**Council submission re: Macquarie University Central Courtyard Precinct Redevelopment  
192 Balaclava Road, Macquarie Park (SSD 8755)**

I refer to your notification letter dated 18 June 2018 advising Council of a Development Application (DA) lodged by Macquarie University for the redevelopment of the Central Courtyard Precinct within the University campus.

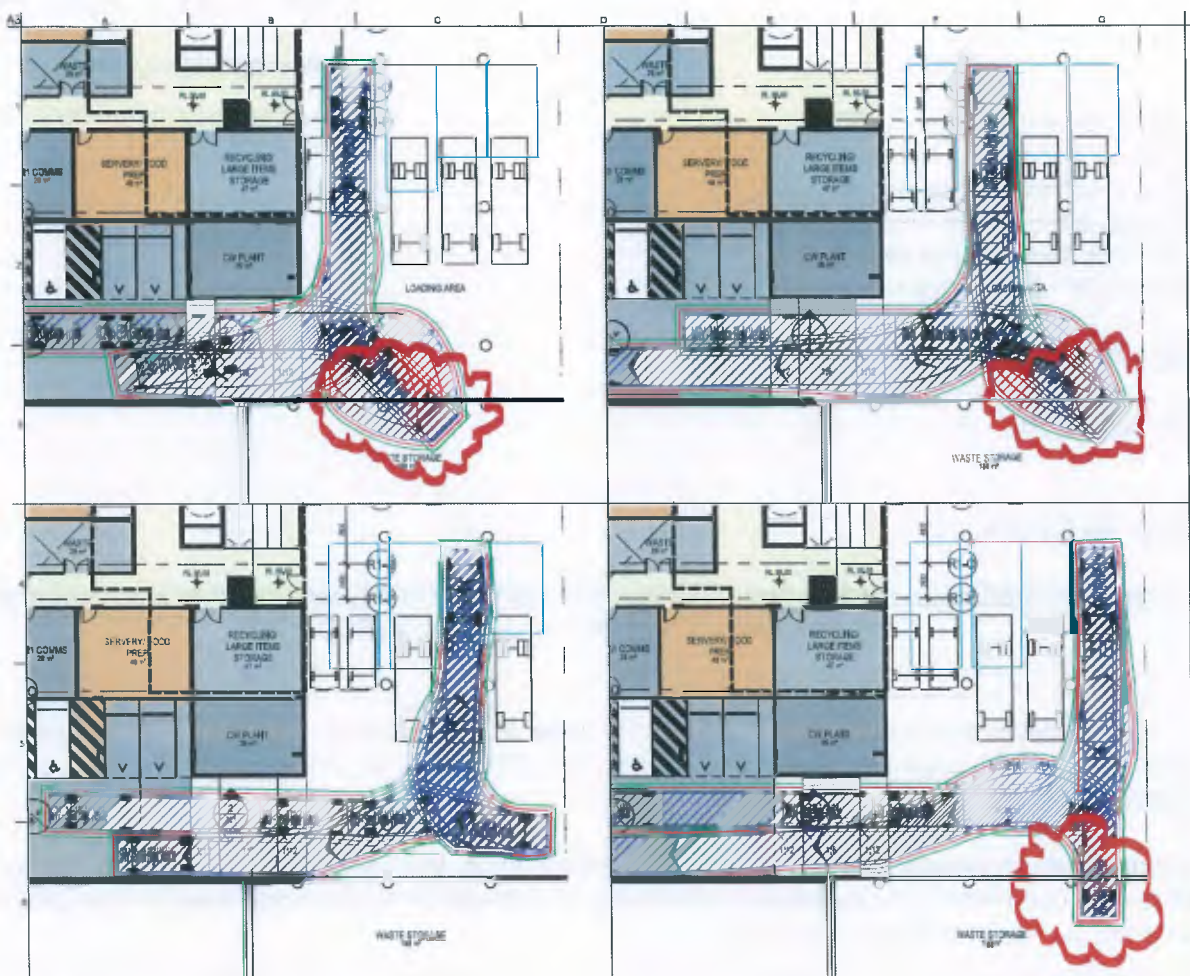
1. The traffic report specifies that the loading dock is proposed to have capacity for two SRVs and two MRVs. However, plans indicate that there will be two SRV spaces and three MRV spaces.
2. Swept path diagrams for 10.24m EPA Garbage Truck, MRV and SRV attached to the traffic report show encroachment as illustrated below:

1. The architectural plans should be amended to clearly show the actual location of the loading and unloading bays and the swept path diagram must be revised so that there is no encroachment.
